Access Compliance Report

Public Rights-of-Way

(Curb Ramps)

Intersection ID: 10289	Main Street: COMMERCIAL_AV	Cross Street: EASTWAY_DR	Location: SW
ADA ID: 201A1C87C552	Ramp Type: BlendTrans1	Initial Pass/Fail: Fail	Overall Compliance: No
Severity Score: 1.25			
Codes/Mitigation Info/Possible Solution		Field Measurements/Component Compliance

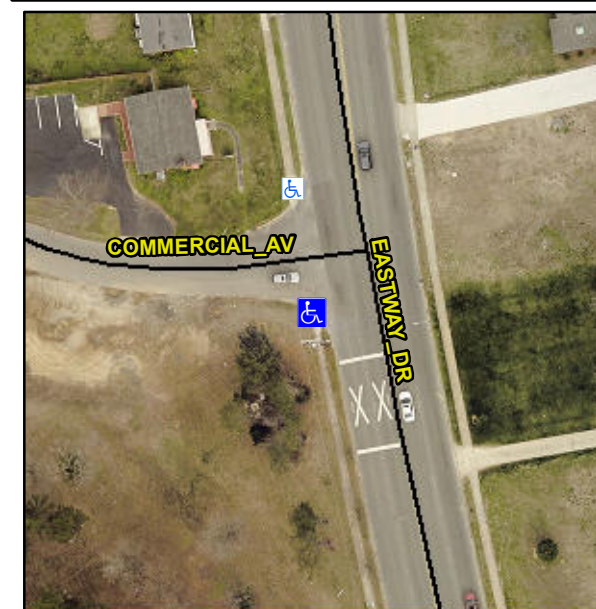
R304.5.3

Compliance	Description	Data	Compliance	Description	Data
N/A	Ramp Length (in)	50.0	Yes	BlendTrans Slope (%)	3.3
Yes	Ramp Width (in)	58.0	No	BlendTrans XSlope (%)	3.0
N/A	Flare Type LT	N/A	N/A	Flare Type RT	N/A
N/A	Flare Slope LT (%)	N/A	N/A	Flare Slope RT (%)	N/A
N/A	Flare Traversable LT?	N/A	N/A	Flare Traversable RT?	N/A
N/A	Landing Length (in)	N/A	N/A	DWS Provided?	N/A
N/A	Landing Width (in)	N/A	N/A	DWS Contrast?	N/A
N/A	Landing Slope (%)	N/A	N/A	DWS Length (in)	N/A
N/A	Landing X Slope (%)	N/A	N/A	DWS Full Width?	N/A
N/A	Landing Curb? (Y/N)	N/A	N/A	DWS Offset (in)	N/A
N/A	Shared Landing?	N/A			
N/A	Gutter Ponding?	N/A	N/A	Gutter Slope (%)	N/A
N/A	Gutter Lip Ht (in)	N/A	N/A	Gutter X Slope (%)	N/A
N/A	Painted X Walk1?	No	N/A	Painted X Walk2?	N/A
	X Walk 1 Direction	To N		X Walk 2 Direction	N/A
	X Walk 1 Width (in)	N/A		X Walk 2 Width (in)	N/A
	X Walk 1 Slope (%)	2.3		X Walk 2 Slope (%)	N/A
	X Walk 1 X Slope (%)	1.1		X Walk 2 X Slope (%)	N/A

Remove & Replace Curb Ramp With Two New Directional Ramps or Equivalent.
